**ADDENDUM NO. 1**

Date: July 29, 2020  
Project: **Rafael Meadows Pump Station Standby Generator Installation**  
Job No.: 12300-05

**SINGLE LINE DIAGRAM (REVISED)**

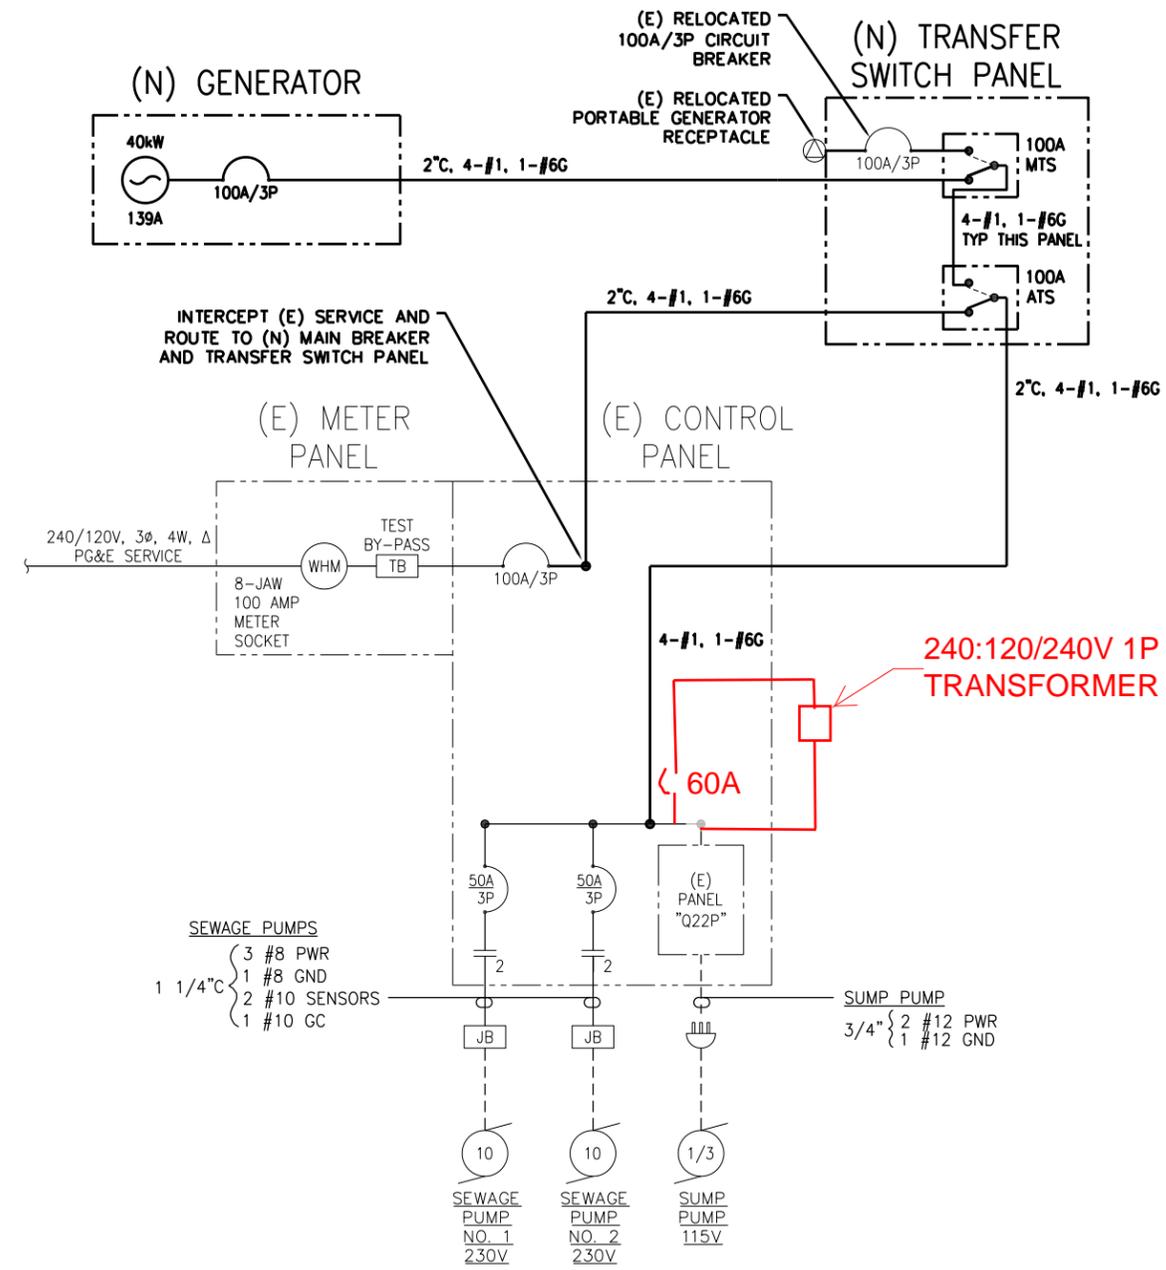
1. Refer to Page 5 of 256, NOTICE INVITING SEALED BIDS, Paragraph 6: Change contract duration from **60 calendar days** to **180 calendar days**.
2. Refer to the attached revised Plan Sheet 8 of 16:

- a. Add one (1) 15kVA 240:120/240 single phase NEMA 3R transformer mounted on existing control panel.
  - b. Add one (1) 60A two-pole circuit breaker for transformer primary protection. Circuit breaker shall be of same type as existing control panel service disconnect. If same type is not available, supply equivalent ABB, Eaton, or Square D circuit breaker.

- c. Revise feeder from 100A service disconnect circuit breaker to transfer switch panel to 3 - #1 & 1 - #6G.
  - d. Revise feeder from generator transfer switch panel to 3 - #1 & 1 - #6G.

- e. Revise feeder from transfer switch panel to existing control panel to 3 - #1 & 1 - #6G.
3. **CLARIFICATIONS:** Delete all reference of Cummins Generator. See Exhibit B for Generator Specifications.
